Bid Addendum

Addendum No. 1 for the City of Staunton Johnson, Byers, and New Street Tunnel Repairs.

Addendum Date: October 28, 2025

From: Wiley|Wilson
Lynchburg, VA

SHT. NO. C-002

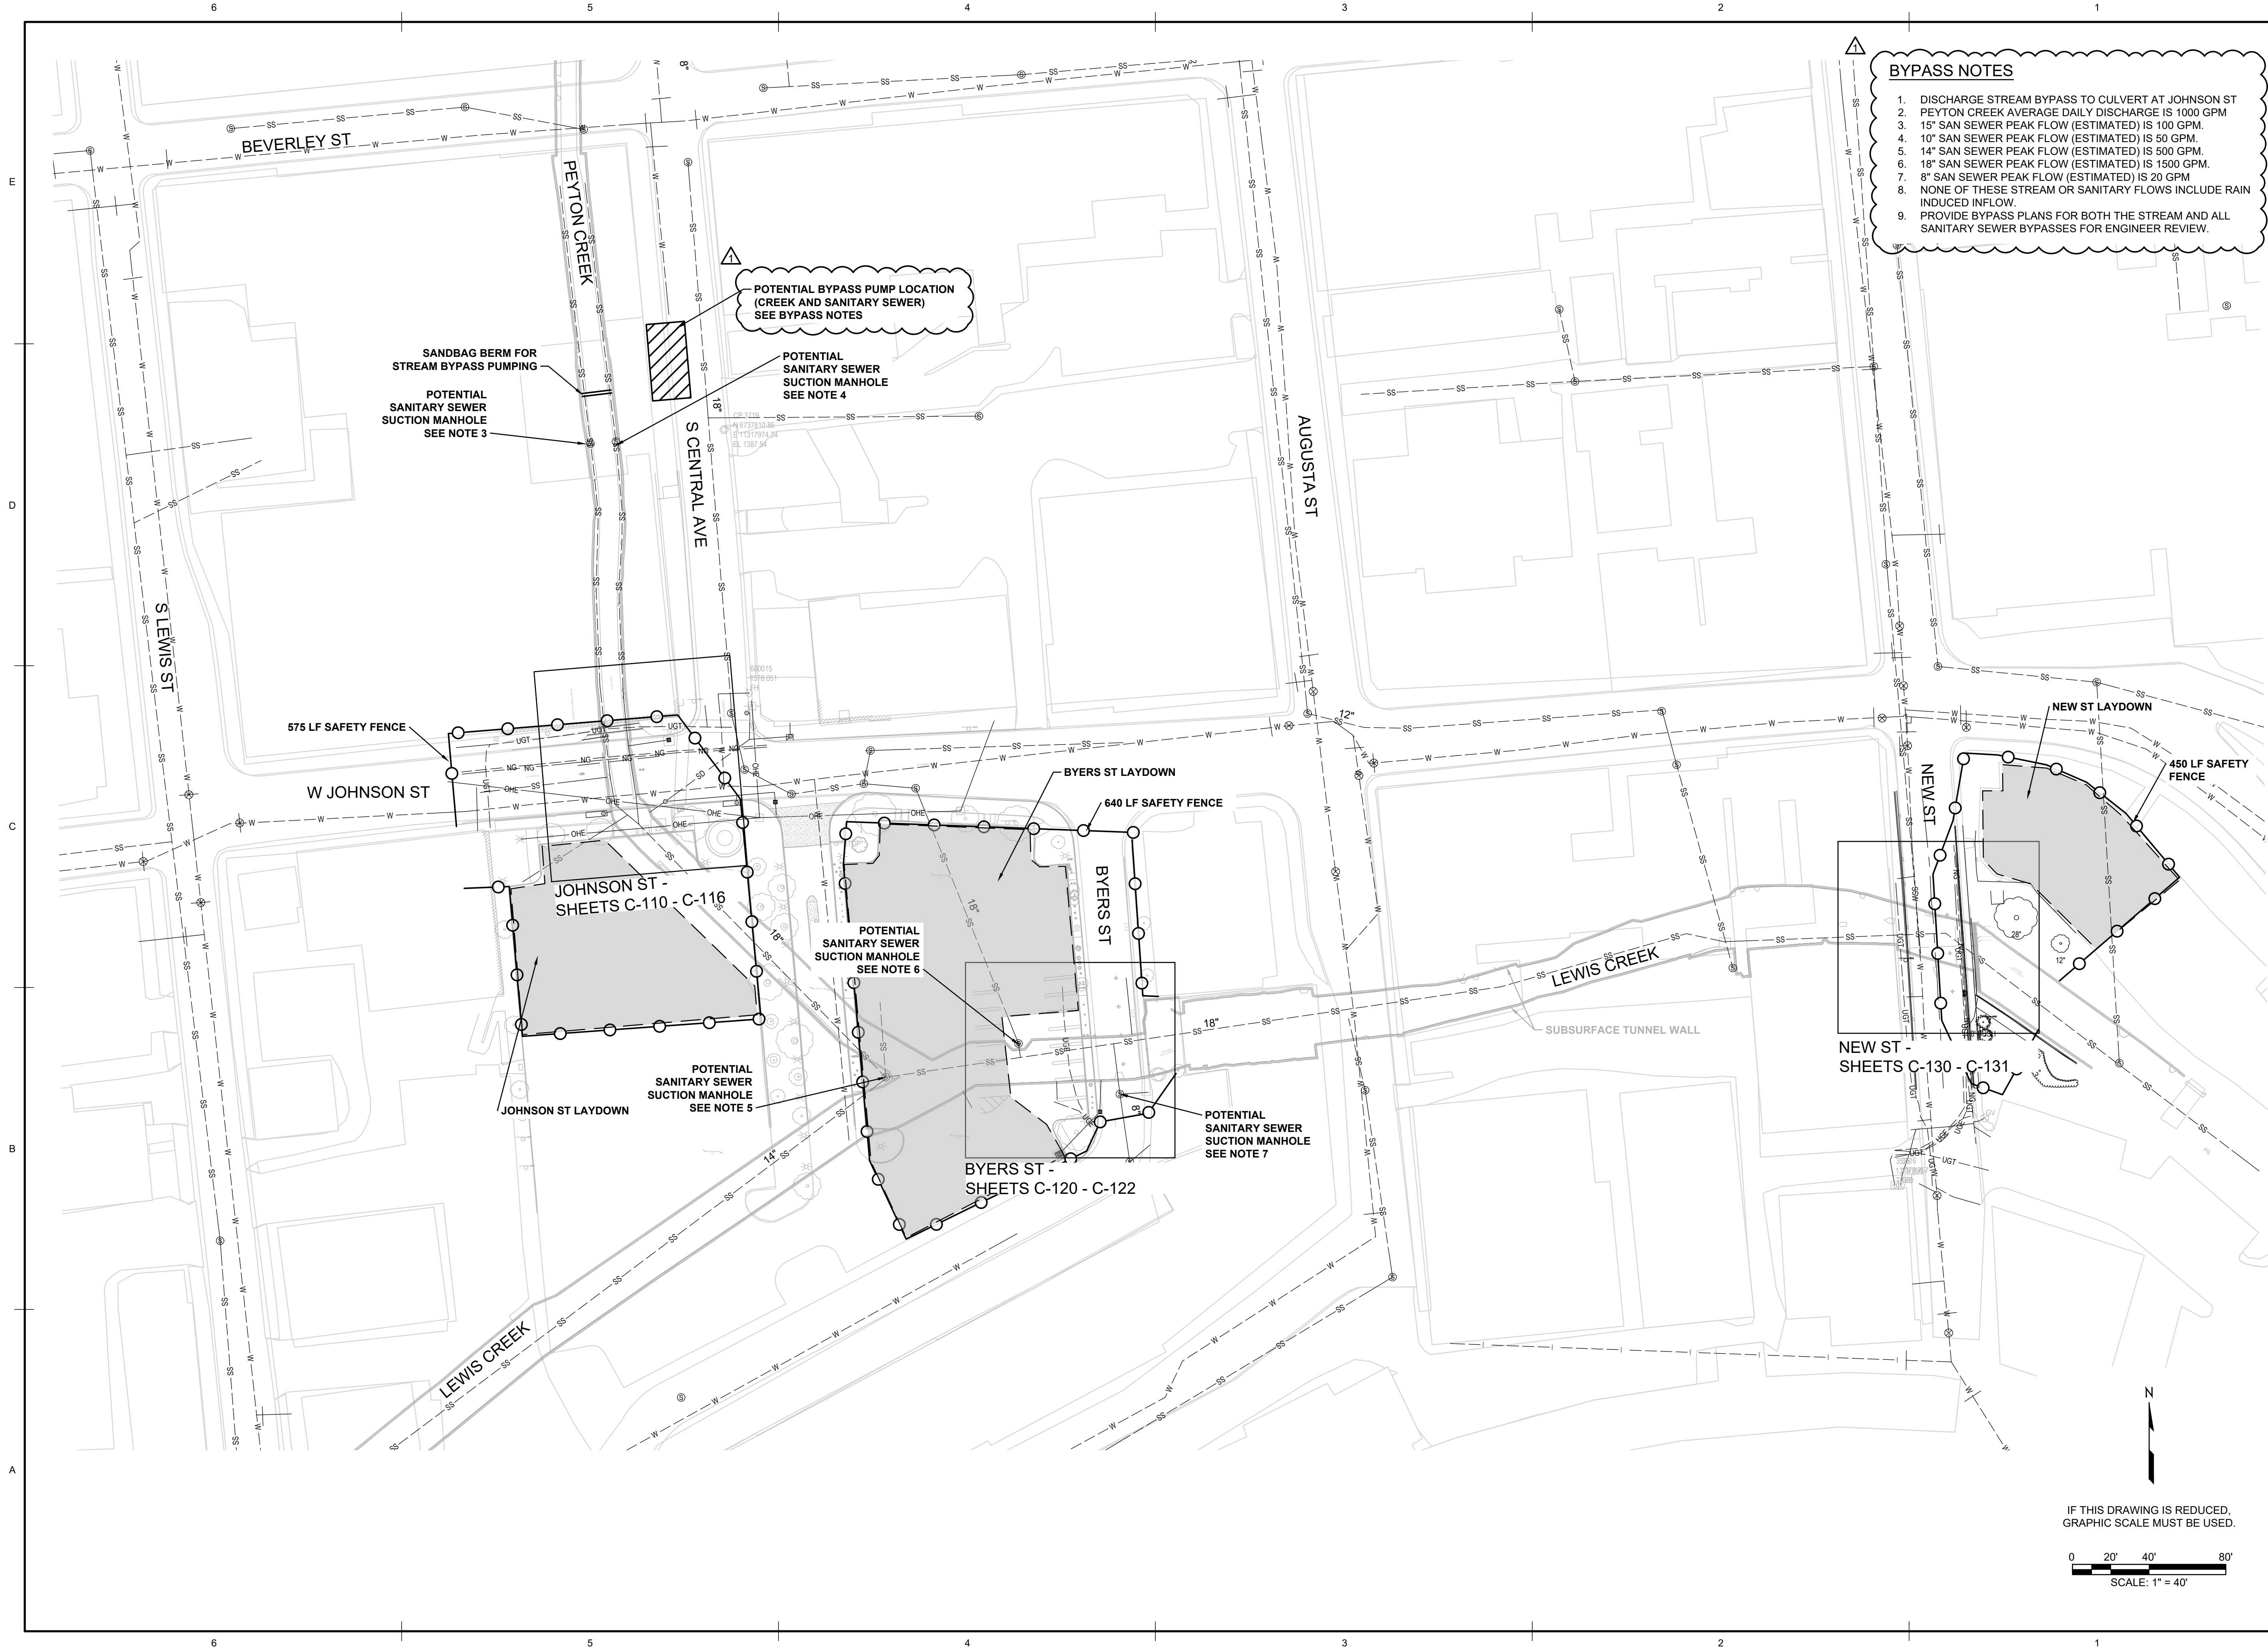
Question 12: Sheet C-002 Bypass note #2: 1,000 CFS seems too big. Are the units supposed to read, "CFM"? Potentially "100 CFS"?

Drawing C-002: Has been reissued to show units change for Note 2 from 1000 CFS to 1000 GPM.

Response: The units noted on Sheet C-002, Bypass Note #2, are incorrect. The bypass flow rate should be 1,000 GPM, which is approximately 2.2 CFS. Sheet C-002 has been reissued with the correct units in this Addendum.

1. DISCHARGE STREAM BYPASS TO CULVERT AT JOHNSON ST
2. PEYTON CREEK AVERAGE DAILY DISCHARGE IS 1000 GPM
3. 15" SAN SEWER PEAK FLOW (ESTIMATED) IS 100 GPM.
4. 10" SAN SEWER PEAK FLOW (ESTIMATED) IS 50 GPM.
5. 14" SAN SEWER PEAK FLOW (ESTIMATED) IS 500 GPM.
6. 18" SAN SEWER PEAK FLOW (ESTIMATED) IS 1500 GPM.
7. 8" SAN SEWER PEAK FLOW (ESTIMATED) IS 20 GPM
8. NONE OF THESE STREAM OR SANITARY FLOWS INCLUDE RAIN INDUCED INFLOW.
9. PROVIDE BYPASS PLANS FOR BOTH THE STREAM AND ALL SANITARY SEWER BYPASSES FOR ENGINEER REVIEW.
